### **Western Sydney Draft Precinct Planning Package Comments**

## Attachment A: Submission Comments

**Figure 1: Penrith Economic Triangle and key connections - which**

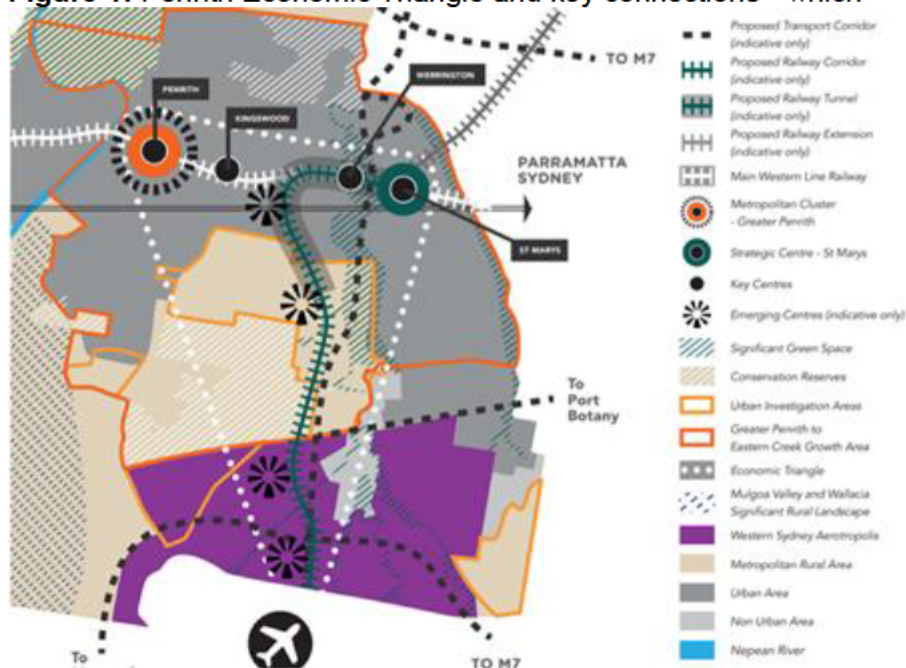
- Council requests that a review be undertaken, particularly against the Northern Gateway, of the key strategic areas of the Penrith Local Government Area identified in the *Penrith Local Strategic Planning Statement* (Figure 1) and the future *North South Corridor Strategy* before finalisation of Aerotropolis Precinct Planning. Delivery of these plans should be parallel to delivery of strategic work for the North-South Rail corridor and East-West Corridor strategies.
